Please receive my submission regarding SSD-9679 – Hills of Gold Windfarm.
This is attached file ref: **240712_IPC_HOGWF_Addit Material**

Submission by [REDACTED] | Dated 12 July 2024

SSD-9679 HILLS OF GOLD WINDFARM (HOGWF) – ADDITIONAL MATERIAL Closing 12pm 15 July 2024

Figure 5-3 Calculated LCOE by technology and category for 2023

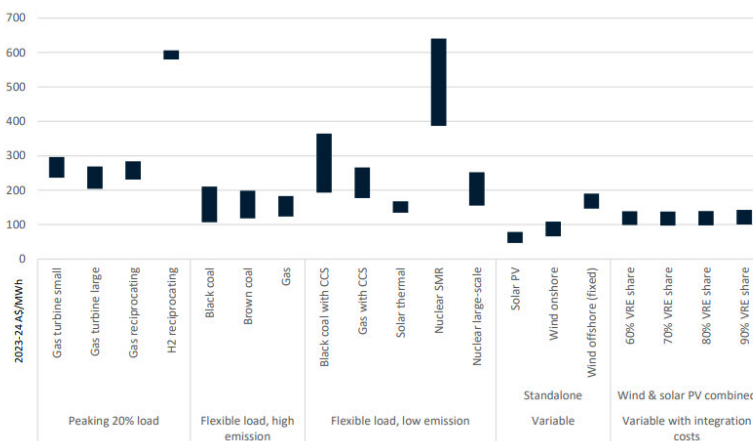
It is further noted from the CSIRO GenCost 2023-2024 (at pp 73) that for Onshore Wind the LCOE range is approximately 65 \$/ MWh to 110 \$/MWh (poor scale from figure). This means that the Hills of Gold Windfarm as tabulated for 62 Turbines (pg i) is at the top of the LCOE range. As such for wind it is relatively a high cost (top of range) producer competing in a market with lower cost producers.

Based on the above, the financial analysis does not consider the income side of the viability question and the Project is a high LCOE cost producer.
